SUBJECT: **144 Seekonk Street Traffic Study**

DATE: **February 11, 2020**

This memorandum responds to TEPP's Traffic Peer Review dated January 28, 2020, which evaluated sight lines for the proposed driveway at the 144 Seekonk Street development ("Lakeland Hills") in Norfolk, Massachusetts based on AASHTO guidance for a 40 mph design speed. We note that the 40 mph design speed was based on speed data collected in December of 2016. Sometime in 2018 an "Intersection Ahead Sign" and 25 mph advisory plaque were installed on Seekonk Street. Speed data collected in November of 2019, after the installation of these speed calming measures, revealed an 85th percentile northbound speed of 38.5 mph, which WSP concludes is an appropriate design speed for sight distances at the proposed driveway. (Southbound sight distance were measured at approximately 36 mph). However, we have evaluated the entrance sight lines based on a 40 mph design speed at TEPP's urging in order to identify any potential sight line encroachments on adjacent properties at this higher speed so as to complete our evaluation using a conservative speed variable.

144 SEEKONK STREET
SB LT TURN SIGHT DISTANCE REQUIRED & AVAILABLE WITHIN ROW
NORFOLK

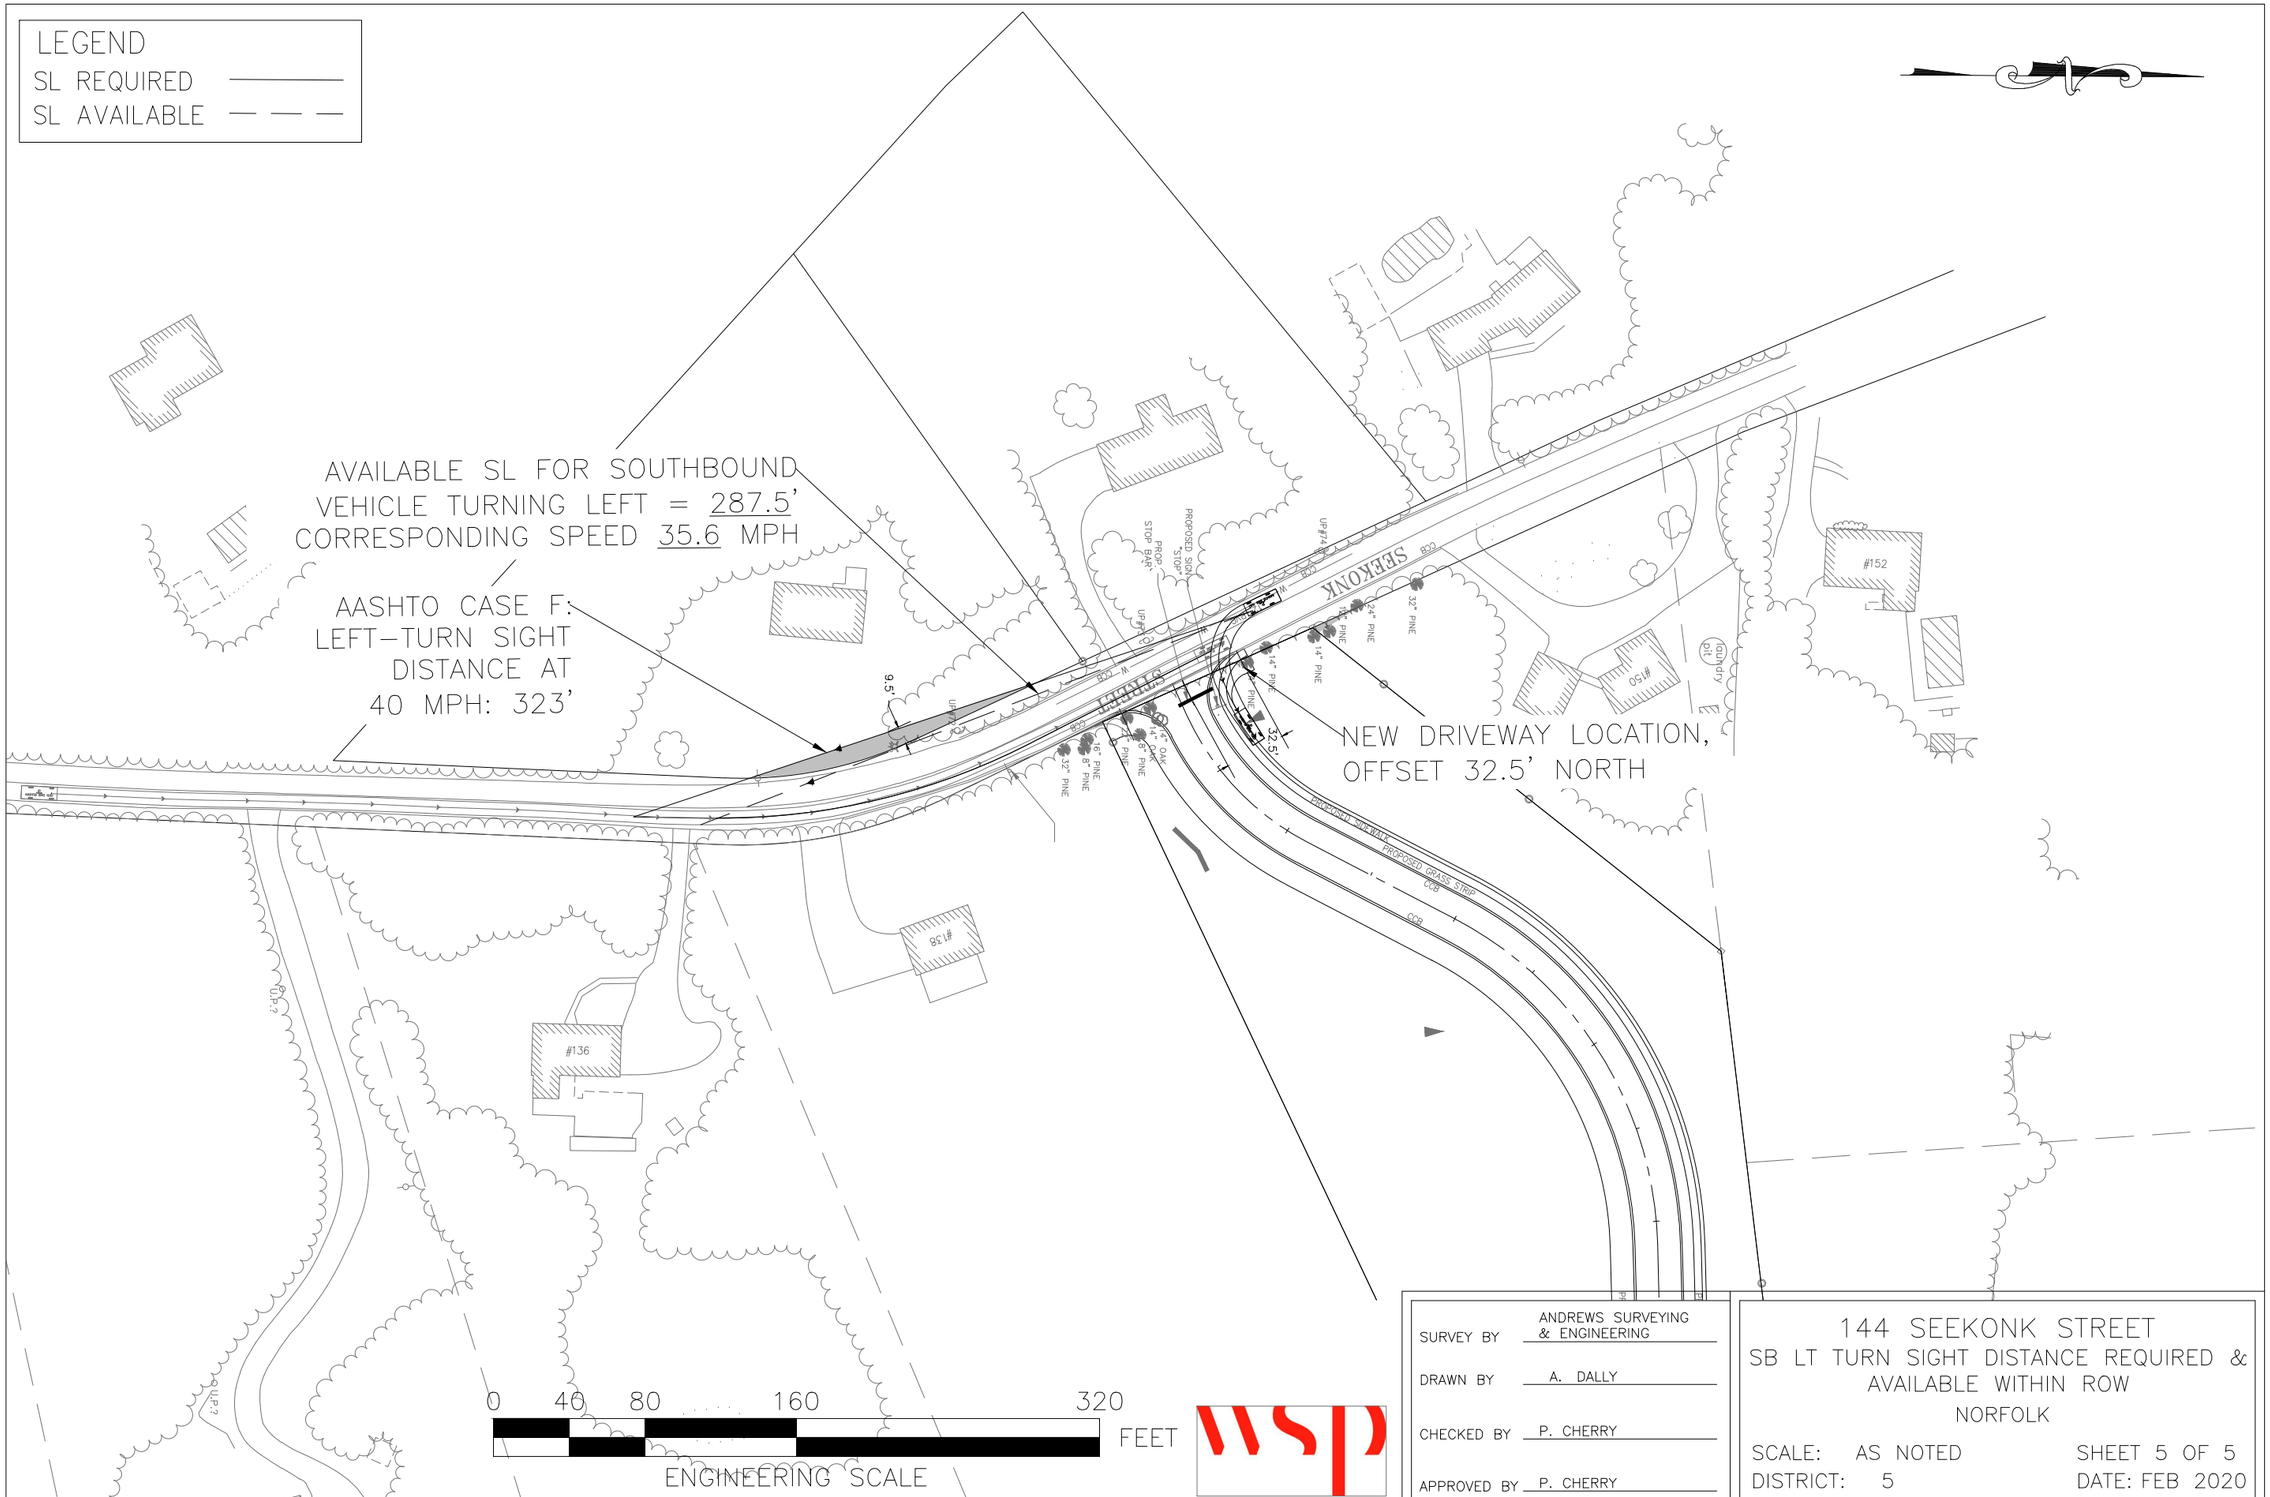
Figure 5 illustrates that there would be 287.5 feet of sight line within the public ROW for a southbound left turning vehicle to see an oncoming northbound vehicle at the proposed driveway relocation. This distance equates to a travel speed of 35.6 mph using the Case F equation; both the distance and speed are approximately 11 percent less than the AASHTO 40 mph value.

However, at 287.5 feet, a northbound vehicle traveling 38.8 mph would have enough time to view, react to, and stop in front of a southbound vehicle (traveling in the opposite,

non-conflicting lane). This 38.8 mph *exceeds* the northbound speed measured in November 2019 and is only 1.2 mph less (approximately 3 percent) than 40 mph. This difference would be mitigated with signage and speed feedback signage. Also note, as left-turning vehicles move further into the northbound lane, they become more visible. Figure 1 shows SSD is maintained within ROW, indicating that northbound vehicles could safely stop if needed.
